Economic and Social Council

World Forum for Harmonization of Vehicle Regulations

Working Party on General Safety Provisions

Report of the Working Party on General Safety Provisions on its ninety-ninth session (19–22 October 2010)

"Annex 2

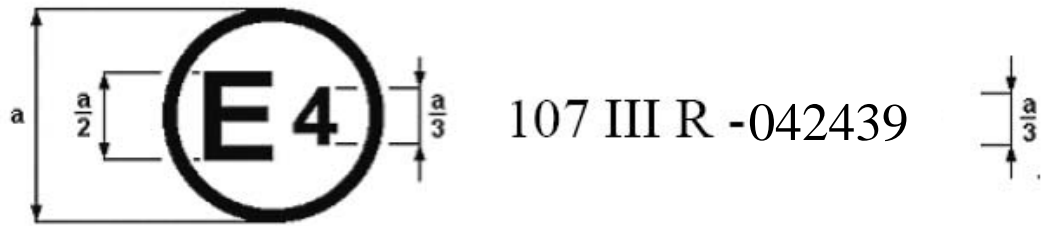
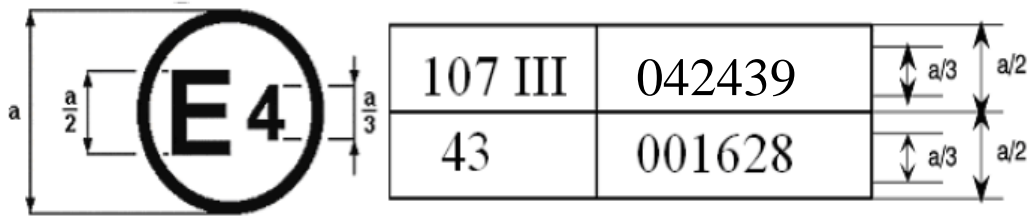
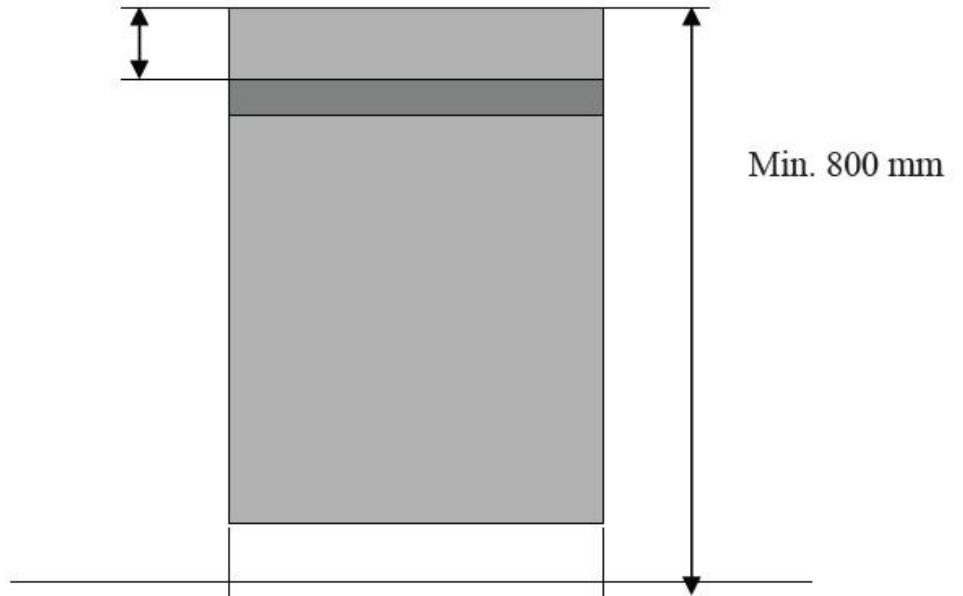
Annex 2, amend to read:

The above approval mark under approval number **042439**. The approval numberas amended by the **04** series of amendments.

The above approval markRegulation No. 107 included the **04** series of amendments and Regulation No. 43 was in its original form.

The above pursuant to Regulation No. 107 under approval number **042439**. The approval number indicates as amended by the **04** series of amendments."

"Figure 1

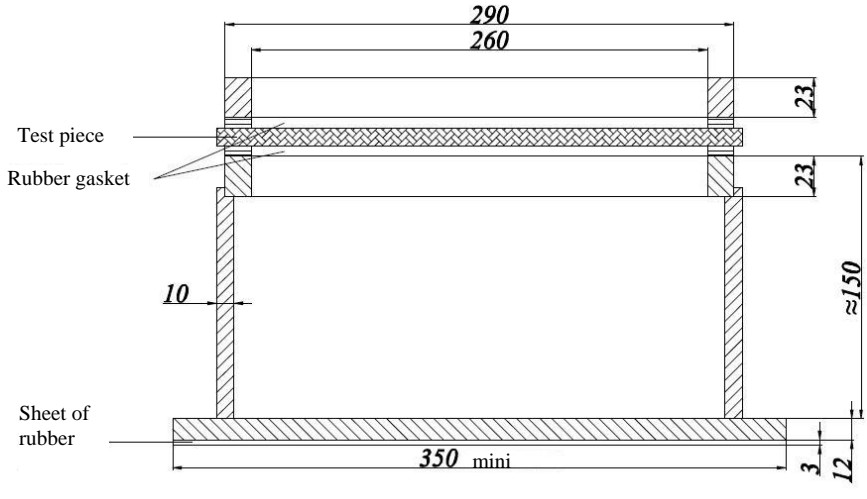
Paragraph 2.1.1.3, figure 1, amend to read:

"Figure 1b

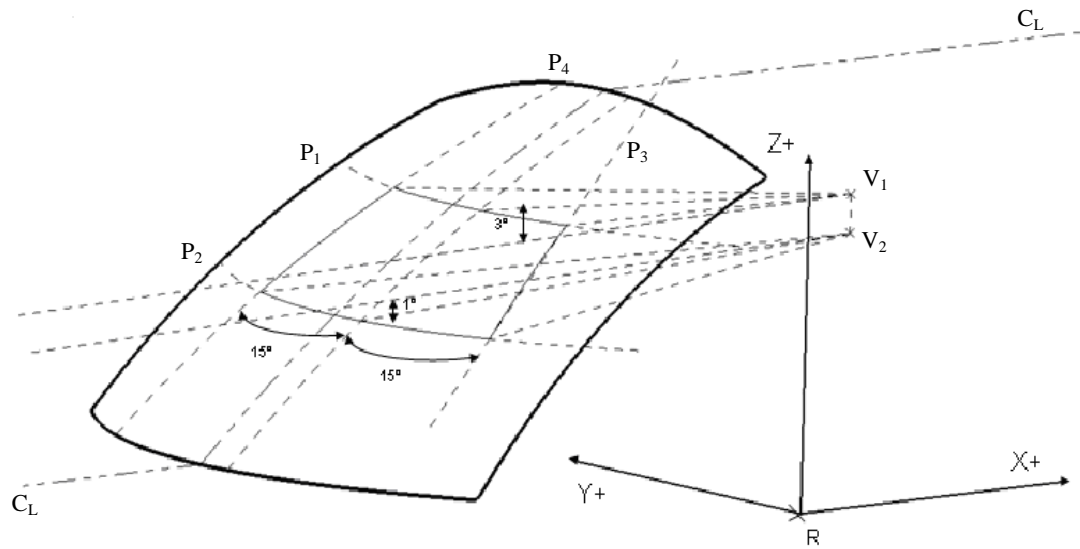
New figure 1b, amend to read:

Test area "A" (example of Central Driving Position)
